## Community Development Code Chapter 58

### 58.020 IMPLEMENTATION

The intent and purpose of this chapter shall be carried out by establishing architectural standards of the 1880 – 1915 period which shall be used in new commercial construction and remodels. The provisions of this chapter shall supersede any conflicting standards found in CDC Chapter 55.

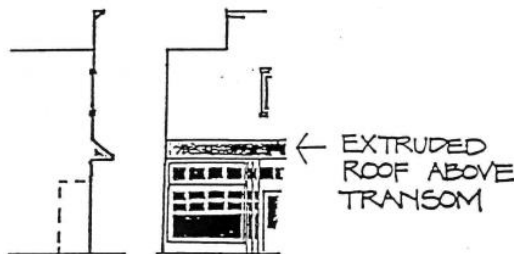
**Commented [FJ17]:** The middle graphic may need to be removed if posts are prohibited in all situations.

**Commented [WD19]:** With the new 12 foot sidewalks, the recommendation is to allow awnings that only cover a portion of the sidewalk as no posts will be allowed for support. Staff recommends removing the specific height requirement and state must meet ADA.

Awnings shall, ~~therefore,~~ extend beyond the front property line to provide appropriate pedestrian coverage the outside edge of the sidewalk, and shall meet ADA requirements, possess a seven-foot clearance to the valance or any other part. The pitch of the awning shall be 10 to 40 degrees. No “bubble-type” awnings are permitted. No backlit awnings are permitted. Canvas or matte-finish vinyl, or similar approved material awnings, may be one-color or striped and shall have a free-hanging plain or crenelated valance. Canvas or matte-finish vinyl, or similar approved material awnings, should not be shared between two structures. Each structure should have its own awning.
